SECTIONAL VIEW

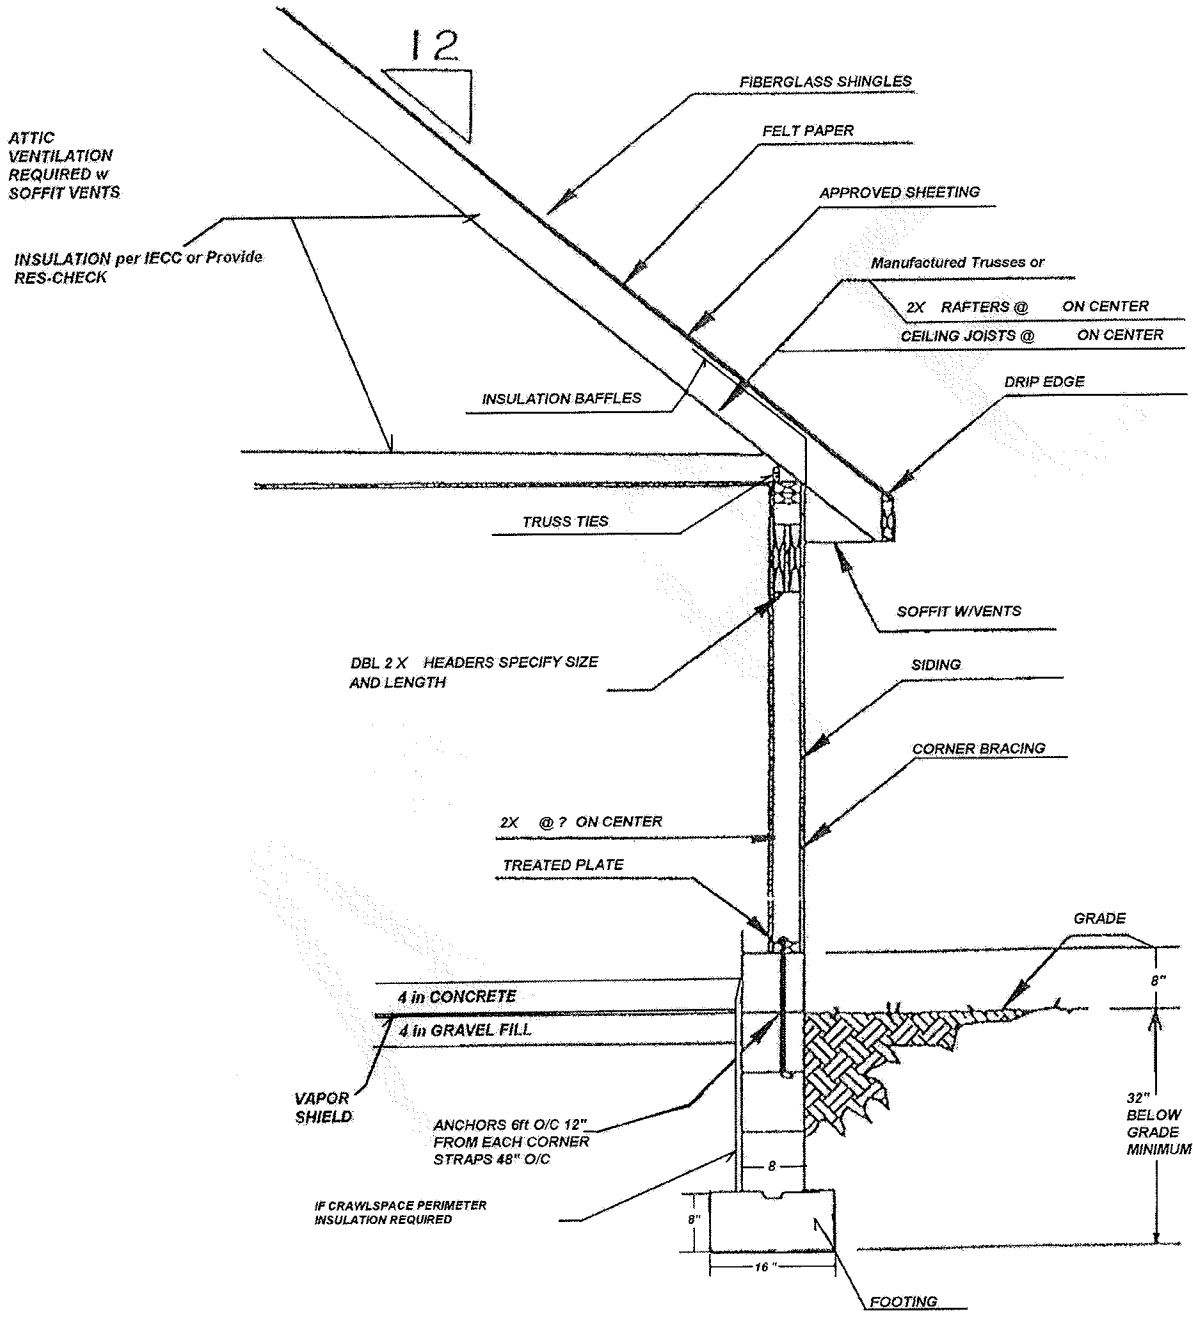
SMOKE ALARMS ARE REQUIRED TO BE HARD WIRED BATTERY BACKUP INTERCONNECTED IN SLEEPING AREAS, HALLS AND ON EACH LEVEL

ATTIC VENTILATION REQUIRED w SOFFIT VENTS

INSULATION per IECC or Provide RES-CHECK

DBL 2 X HEADERS SPECIFY SIZE AND LENGTH

VAPOR SHIELD

IF CRAWLSPACE PERIMETER INSULATION REQUIRED
